RESPONSE LETTER NO. 3 TO REQUEST FOR INFORMATION

Project Title: **South Dade Transit Operations Center (SD TOC)**
Project No.: **CIP227A-DTPW22-CT**

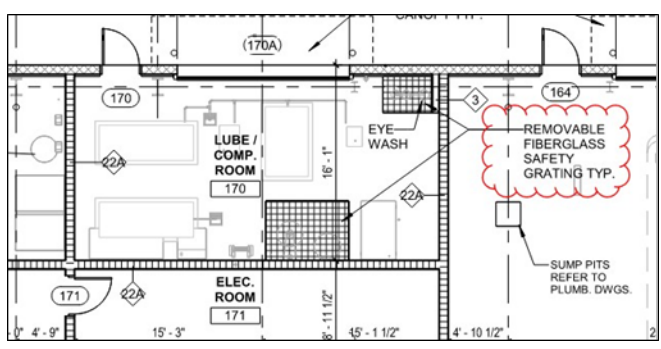
- QUESTION No.7:** Building 1 - Life Safety Legend on Life Safety Plan (BM-1ALS-110) calls for a "Two Hour Rated Wall" for the Steel Column Enclosure at Running Repair Bay, Air Conditioning Repair Bay, Body Repair; however, Ground Level Floor Plans (BM-1-AFP-210, BM-1-AFP214, BM-1-AFP-215) do not call or show any enclosure for the columns. Please confirm if the two-hour rated wall is required for the steel columns.

ANSWER No.7: Refer to note on Life Safety Plan. No cover on columns. All primary structure to be protected with 2-hour rated intumescent paint.

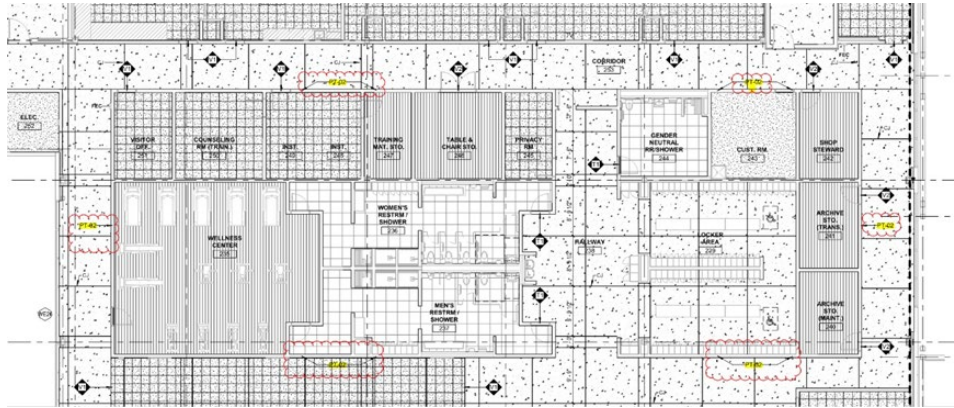
QUESTION No.8: Please advise if the owner will provide the Removable Fiberglass Safety Grating. If not, please provide specifications.

ANSWER No.8: Sink, eyewash and eyewash/sink combination are removable fiberglass safety grating. All other grating indicated galvanized steel. Specification Section to be provided via addendum.

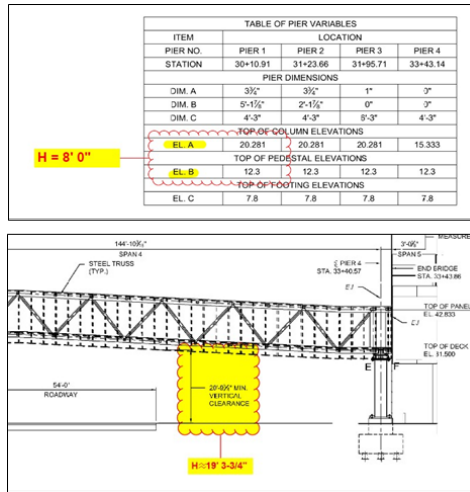
QUESTION No.2: In building 1, sheet BM-1-ARP-220 shows a Catwalk and refers to the structural drawings. Also, you can find on sheet BM-1-ISC-106 a reference to see the structural for the catwalk and mechanical for catwalk movement, but we could not find any specific structural drawing with this information. Please provide it.

ANSWER No.2: Catwalk drawings will be issued via Addendum.
